Proposed Access onto Telegraph Road, St Mary's

Statement of Highway Impact

CORMAC Consultancy
Radnor Road, Scorrier, Redruth, Cornwall, TR16 5EH

Fig. 2 Existing Site Access Onto Telegraph Road

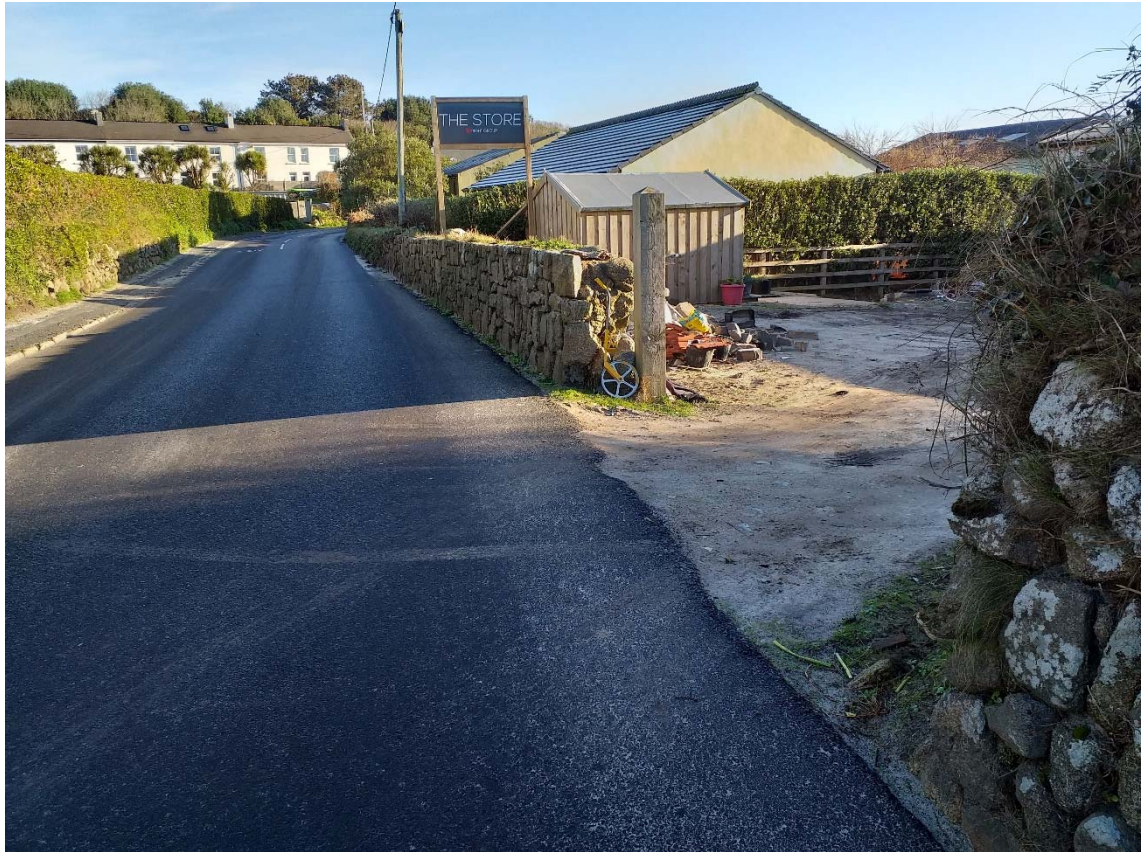
- 2.1.2 The only footway is on the northern side of the road, the opposite side from the application site. On the south side, where there is no verge or footway, vehicles leaving the site emerge directly onto the carriageway (Fig. 2).

Fig. 3 Extract from Applicant's Drawing 1977-P08 rev. D (Visibility Splay Highlighted)

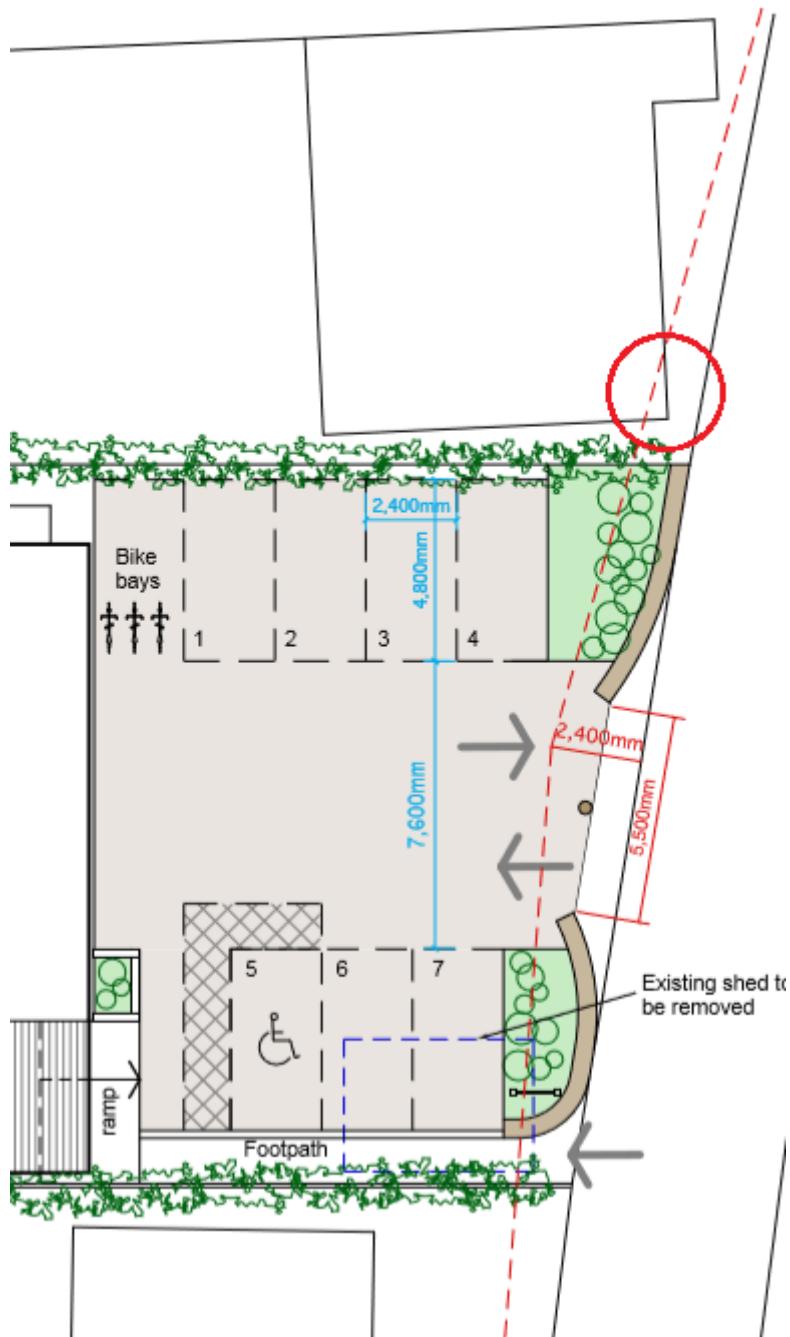
- 3.1.3 By maximising the available room on site, the end spaces – nos 4 and 7 on the application drawing (Fig. 3) – are barely 3m from the edge of the road. The distance is too short for vehicles leaving these spaces (particularly in forward gear) to straighten up before they reach the road. Their angled exit onto the road could:

- (a) require a three point turn within the carriageway, and
 - (b) cause vehicles entering the site to wait until the car park entrance is clear.
- 3.1.4 Either of these scenarios could be prejudicial to highway safety. Users of the A3111 can reasonably expect traffic to flow freely. So whilst these scenarios could describe typical everyday manoeuvres within a built-up area, they are not typical of a site that is on a main road, the edge of the town.

- 4.2.1 The visibility splays on the applicant's drawing show x- and y-distances of 2.4m and 43m respectively, which correspond with the minimum standards of stopping sight distance in the Manual for Streets (par. 7.7.10 and Table 7/1). However, neither visibility splay is achievable, in that it encroaches on land that is outside the control of the applicant. Both to the left and to the right of the proposed access, the sight line crosses neighbouring land; and in the case of the sight line to the left, it actually appears to cut through the corner of a building.

- 4.2.2 Granted, inaccurate Ordnance Survey mapping could account for the building appearing to obstruct visibility. So at the very least, an accurate local survey would be needed to confirm the true position of the building. Notwithstanding that, the underlying issues are that

- (1) the visibility splays are largely outside the control of the applicant, and
 - (2) the planning authority is not able to grant consent with visibility-related conditions which can be enforced.

- 4.2.4 Until such time as the whole of the splays can be included in the planning application, they should be disregarded. On that basis, using the same x-distance of 2.4m, the achievable y-distance amounts to only 9m to the left and right (equivalent to half the width of the plot). The minimum distance of 43m cannot be achieved until the driver's eye is at (or very close to) the edge of the road, by which time the vehicle is protruding into the carriageway by 2m or more.

- 5.1.5 When taking into account the dimensions of the site, the true sight lines measure only 9m to the left and right of the proposed access.
- 5.1.6 Although the 85th percentile speed on Telegraph Road is less than 30mph, the application has not provided sufficient evidence that a safe and satisfactory access can be provided. In the interests of highway safety it is recommended that the application be refused.
